Project	Steamboat Base Village Redevelopment	Date	07/22/2021
Project Location	Steamboat, Colorado	Architect's Project Number	03.7835.000
Owner/Client	Alterra Mountain Company / East West Partners	File	6BL This is page 1 of 3
To	Saunders Construction Inc.	Attention	Bryan Sculthorpe
Address	86 Inverness Place North		
City	Englewood	State	CO Zip Code 80112
Delivered via:	☐ Messenger ☐ Hand carried ☐ Facsimile ☐ Express ☐ Pick-up ☐ E-mail Address ☐ Mail ☐ UPS ☒ Website Address BIM360

Bulletin Number - BP3 Promenade - 05

Description of Changes

Foundation and Lower Level Floor Plan Changes in the Promenade Building

1A-S1.00

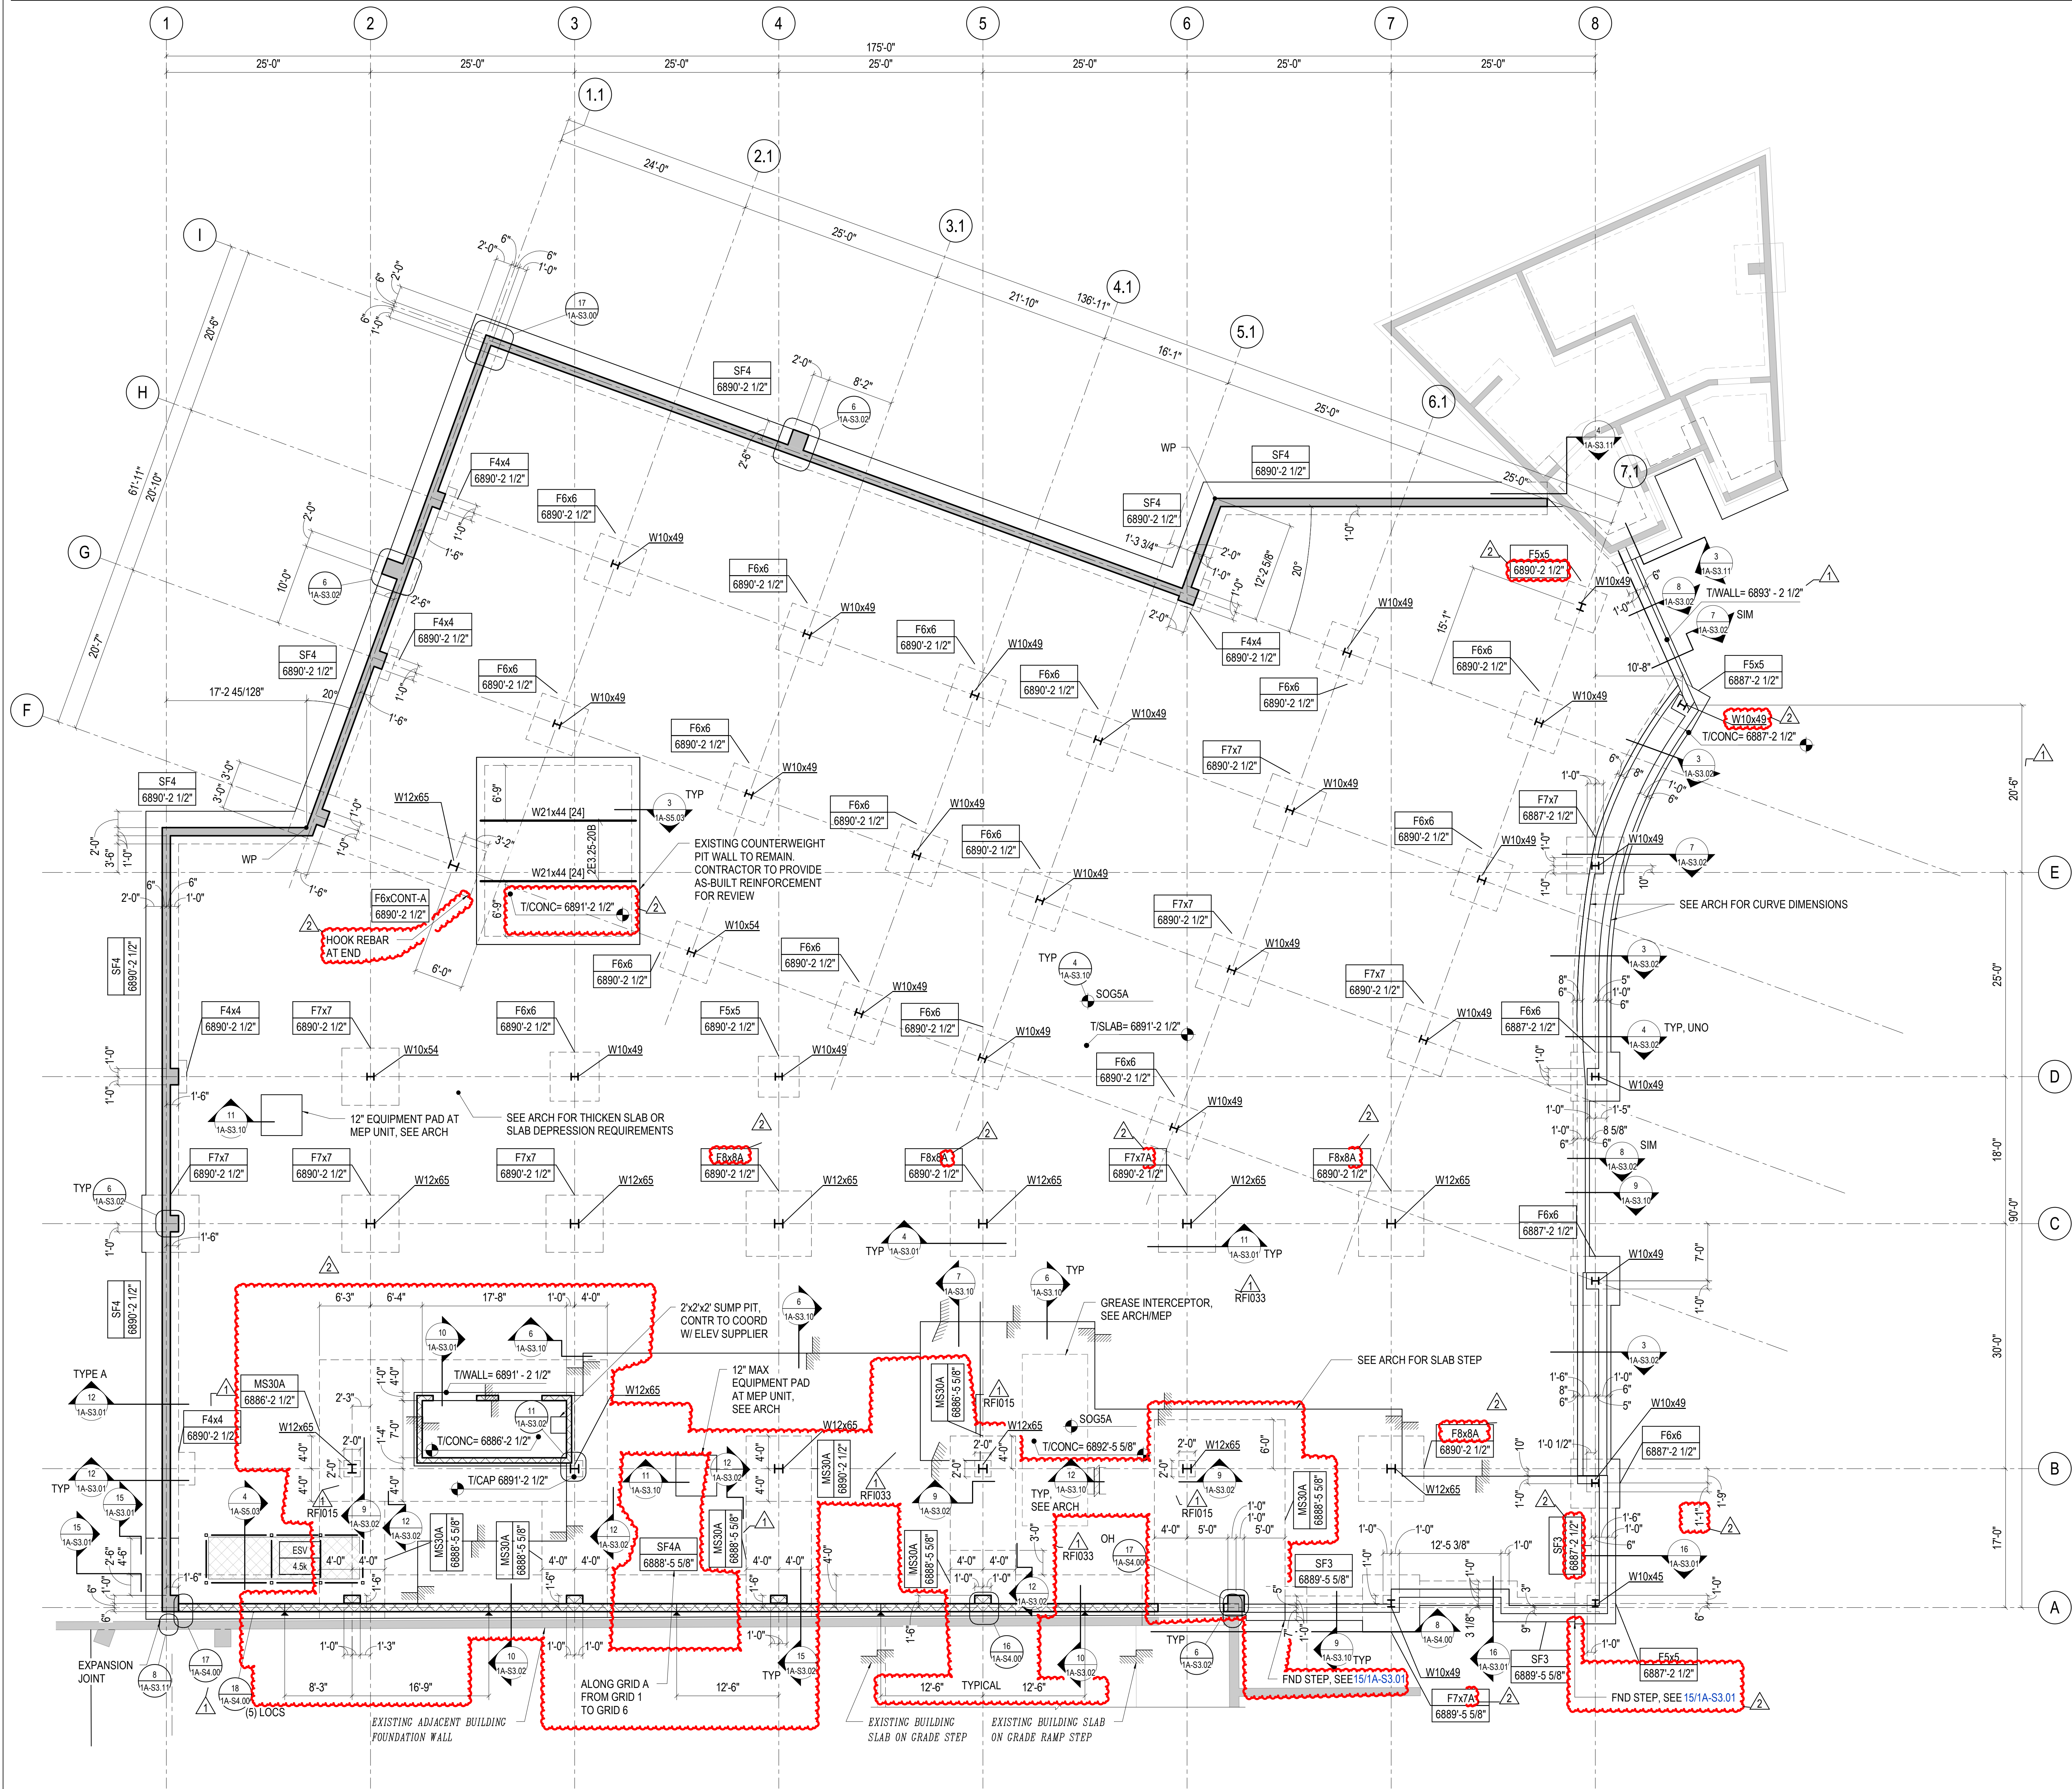
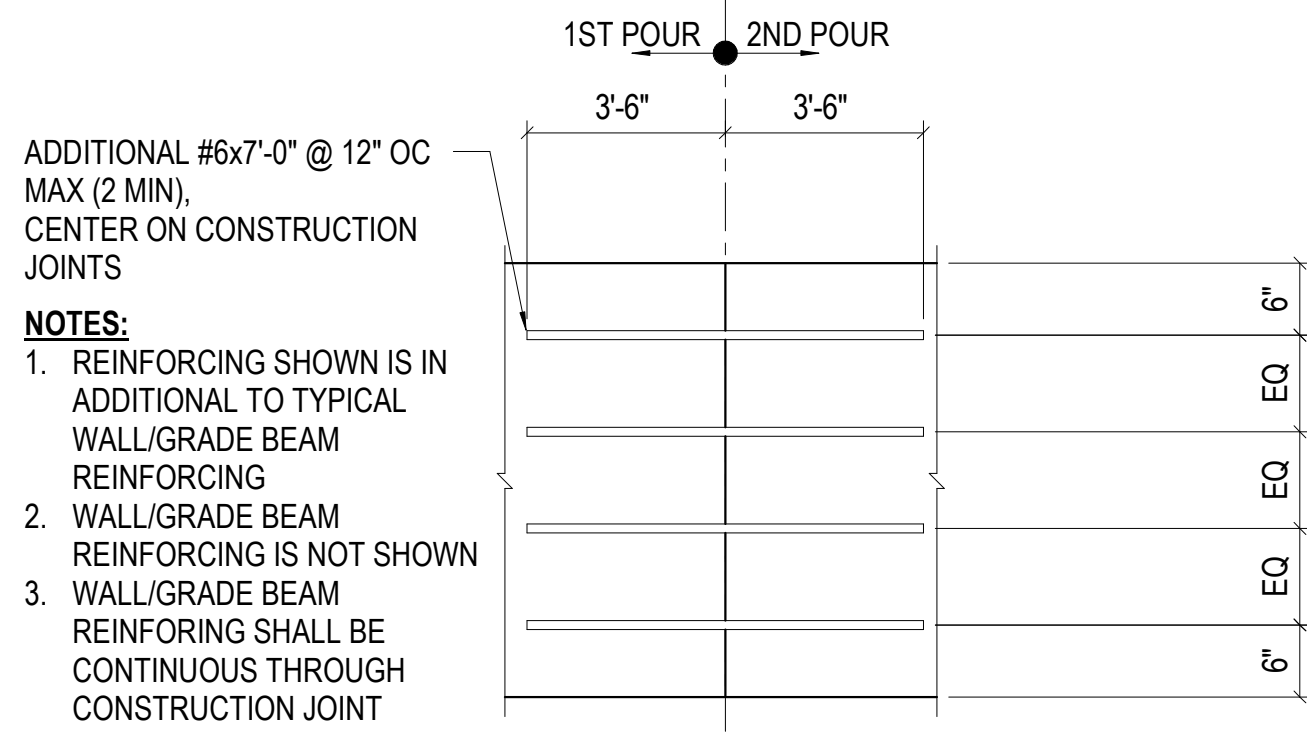
1. 1A-S1.00
 - a. Top of slab elevation is clarified at existing pit slab
 - b. 'F6xCONT-A' reinforcement hook requirement is clarified to match shop drawing.

- c. Footing elevation at grid 7.1/8 is revised.
 - d. Steel column size at grid E.5/8.5 is clarified.
 - e. Footing elevation is revised at grid A/8.
 - f. Foundation step location is clarified.

- g. Pilaster dimension at grid B/8 is clarified.
 - h. Combined footing at grid A/2 to B/2 is revised.
 - i. Elevator footing is revised.
 - j. Combined footing at grid A/3 to B/3 is revised.

- k. Combined footing at grid A/4 to B/4 is revised.
 - l. Combined footing at grid A/5 to B/5 is revised.
 - m. Combined footing at grid A/6 to B/6 is revised.

- n. CMU control joint location is revised.
 - o. Spread footing at Grid A/7 is revised.
 - p. Spread footing at Grid B/7 is revised.
 - q. Spread footing at Grid C/4 is revised.

- r. Spread footing at Grid C/5 is revised.
 - s. Spread footing at Grid C/6 is revised.
 - t. Spread footing at Grid C/7 is revised.
2. 1A-S3.01
 - a. Detail 4:

15 3/4" = 1'-0" STRIP FOOTING w/CIP STEM WALL STEP, 3'-0" AND LESS

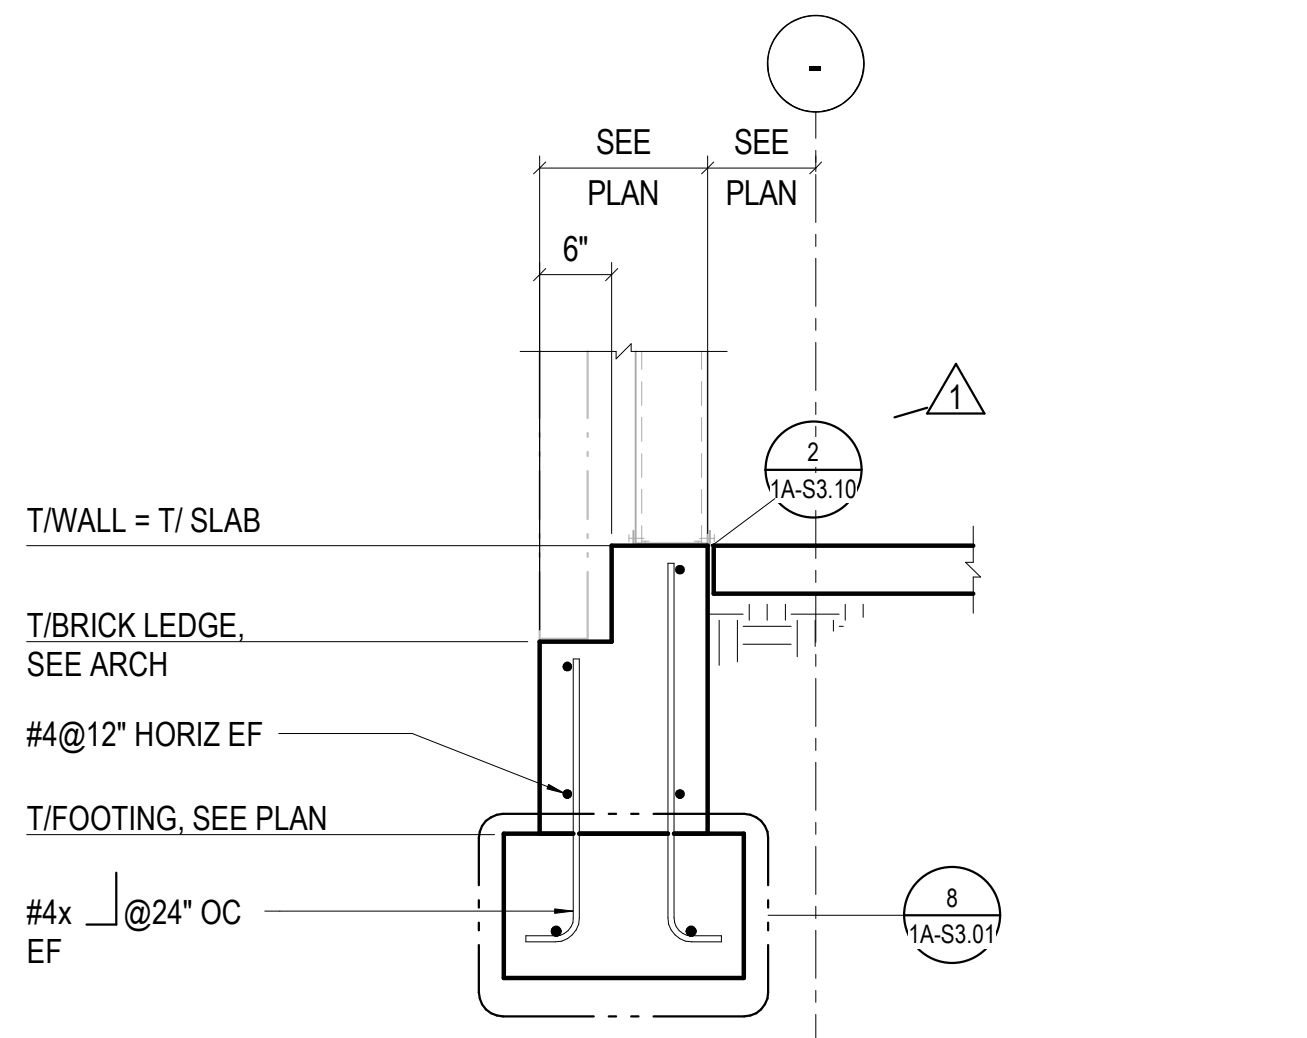
- c. Detail 11:
 - i. Detail is added.
- d. Detail 12:
 - i. Detail is added.
- e. Detail 15:
 - i. Detail is added.
- f. Plan 1:
 - i. F4x4 footing added for future column location at grid B/1.

10 NO SCALE ELEVATOR PIT ON FOOTING

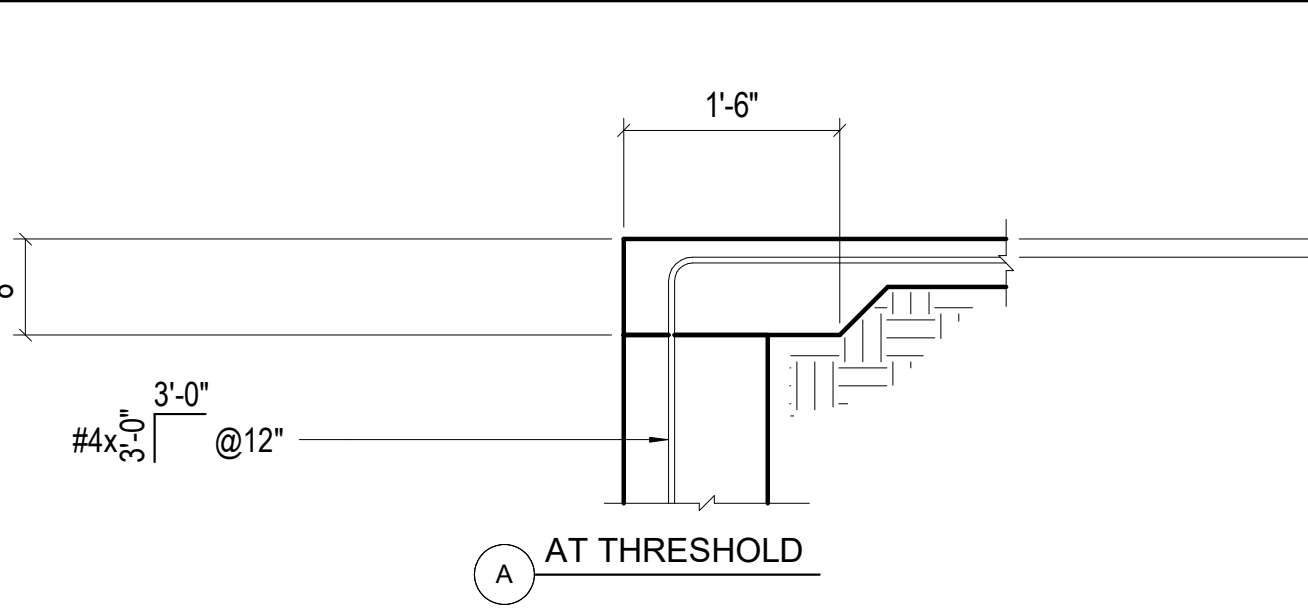
- i. F7x7A and F8x8A footings are added.
 - b. Detail 8:
 - i. MS30A is added.
 - c. Detail 10:
 - i. Elevator footing is revised.
3. 1A-S3.02
 - a. Detail 3:

1A-A1.200

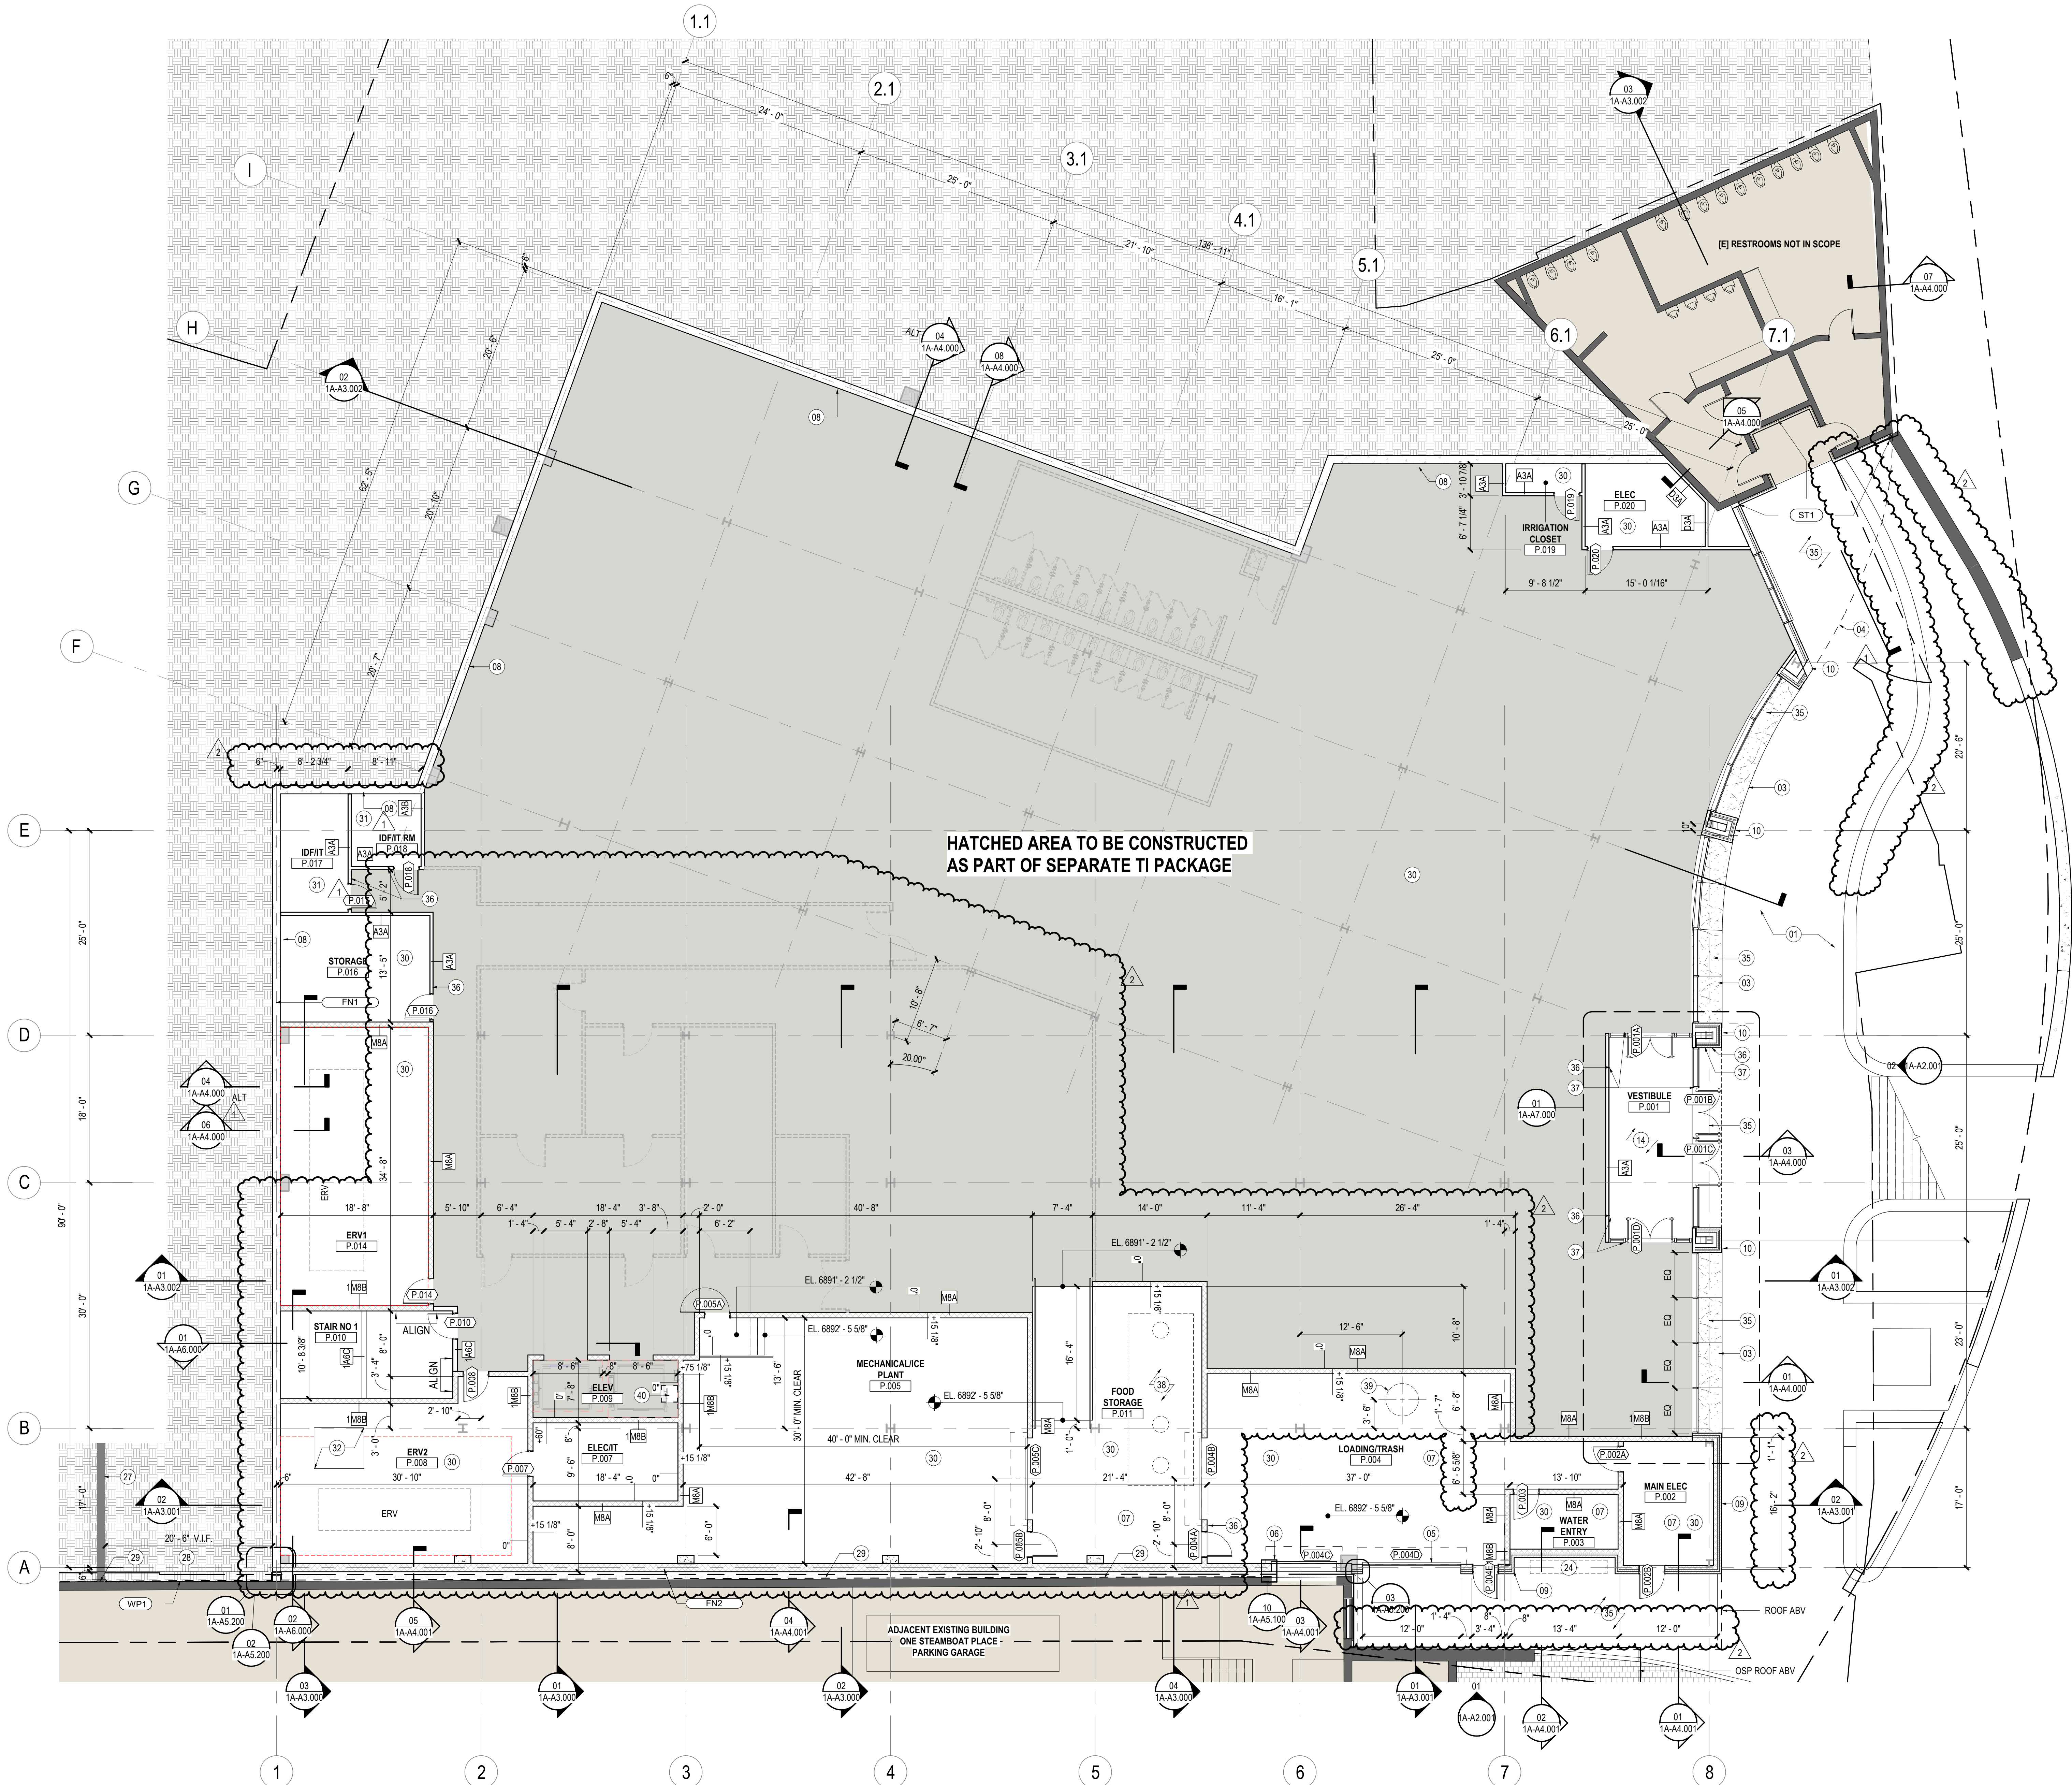
1. 1A-A1.200
 - a. Revised CMU walls to accommodate additional elevators and structural changes.
 - b. Revised concrete ramp location and slope at gridline 5
 - c. Revised Electrical Room P.007 location and size
 - d. Removed tenant areas from Summer 2021 scope
 - e. Revised landscape walls at Stage Restroom entry
